TVA-BFN-TS-441R1

BROWNS FERRY NUCLEAR PLANT (BFN) - UNITS 2 and 3 - TECHNICAL SPECIFICATIONS (TS) CHANGE TS-441 REVISION 1 - UPDATE OF PRESSURE-TEMPERATURE (P-T) CURVES

PROPOSED TECHNICAL SPECIFICATIONS (TS) CHANGE TS-441R1 TVA EVALUATION OF PROPOSED CHANGE

Figure 3.4.9-2
Pressure/Temperature Limits for
Reactor In-Service Leak and Hydrostatic Testing

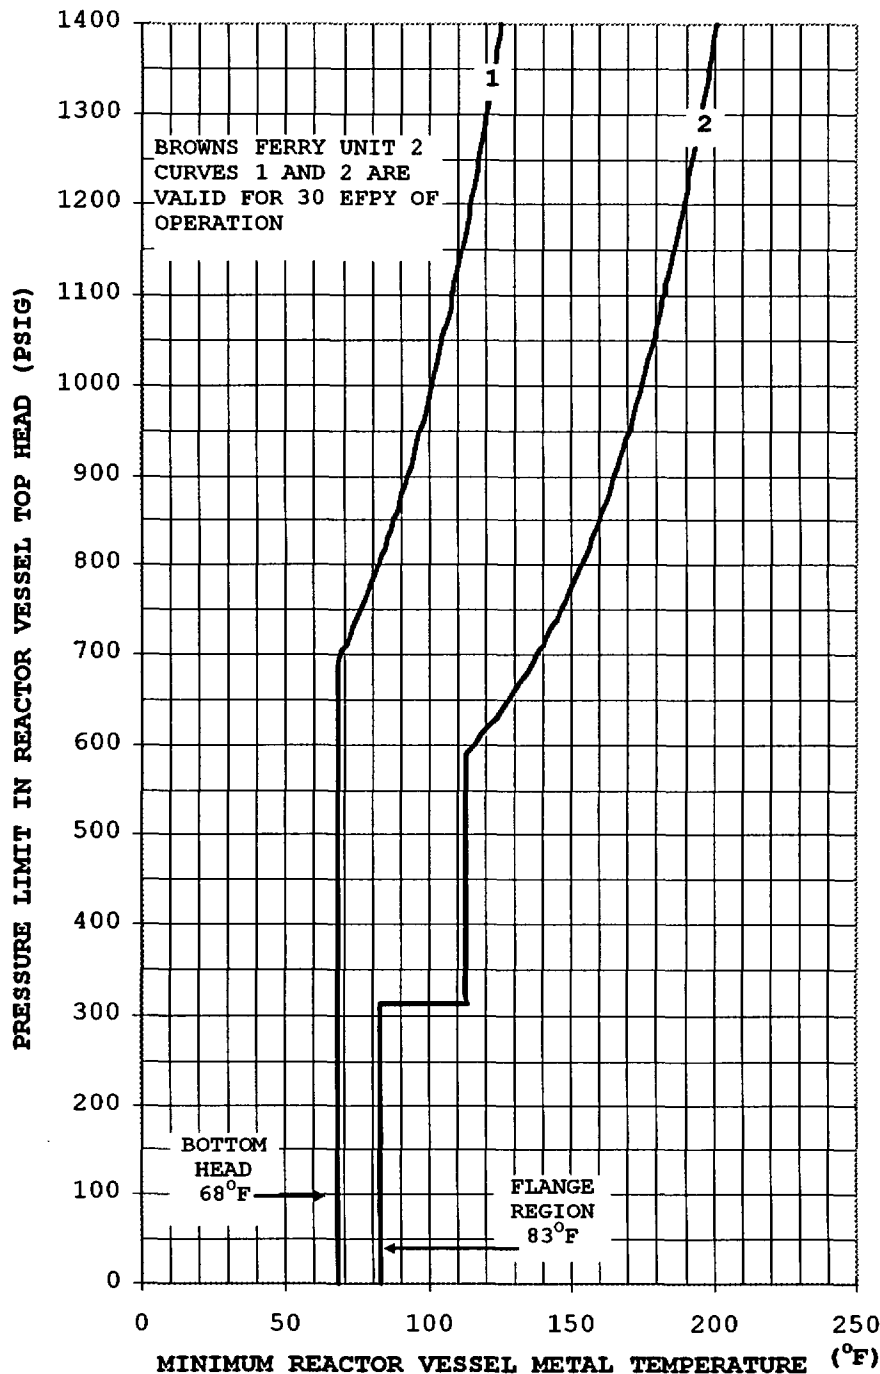
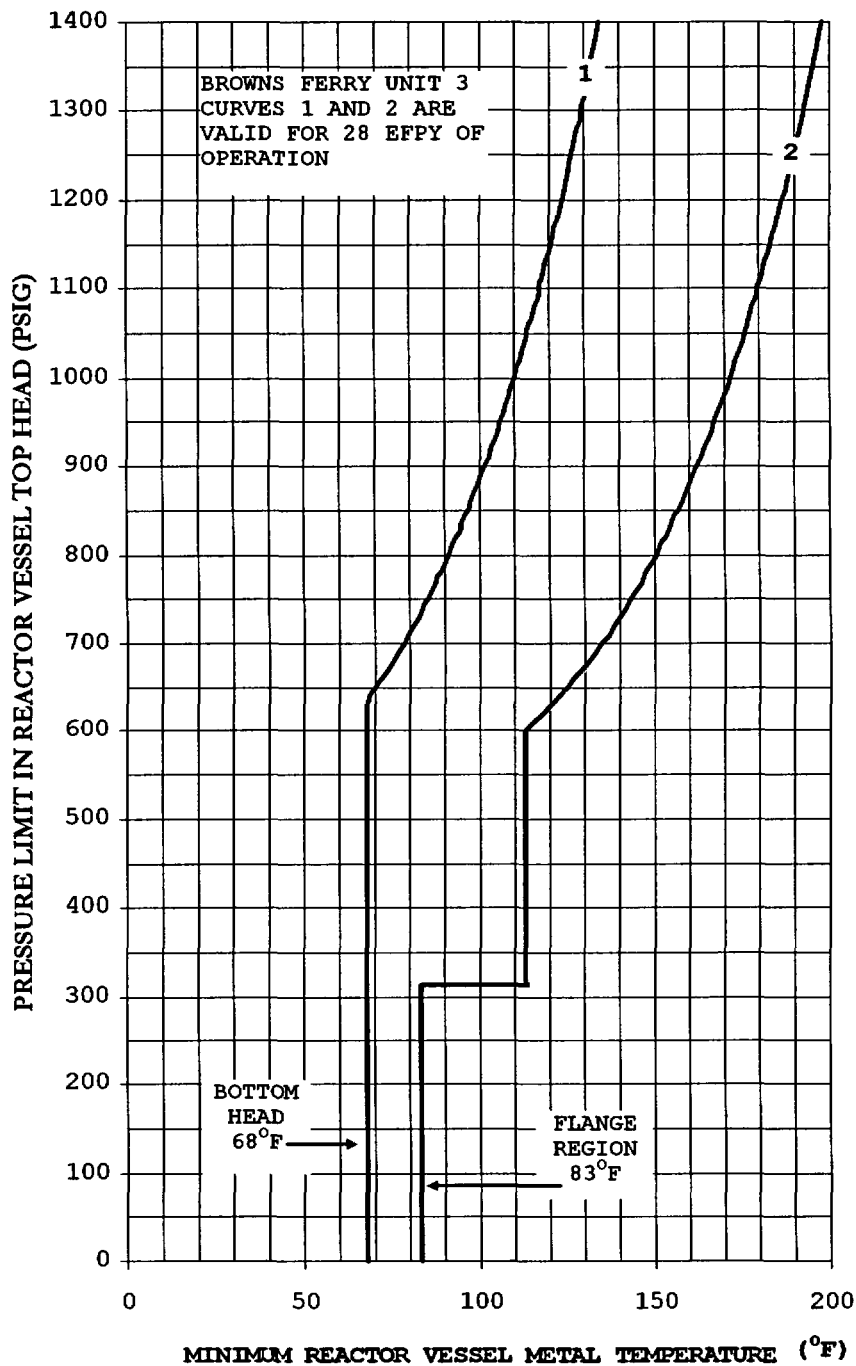
These pages are submitted for NRC review and approval, however, they will not be placed into the BFN TS at this time. As Unit 2 approaches 23 EFPY, and as Unit 3 approaches 20 EFPY, TVA will replace the TS figures shown in Enclosure 3 above with these figures.

Curve No. 1
Minimum temperature for
bottom head during
in-service leak or
hydrostatic testing.

Curve No. 2
Minimum temperature for
upper RPV and beltline
during in-service leak or
hydrostatic testing.

Notes
These curves include
sufficient margin to
provide protection against
feedwater nozzle
degradation. The curves
allow for shifts in RT_{NDT}
of the Reactor vessel
beltline materials, in
accordance with Reg. Guide
1.99, Rev. 2, to
compensate for radiation
embrittlement for 30 EFPY.
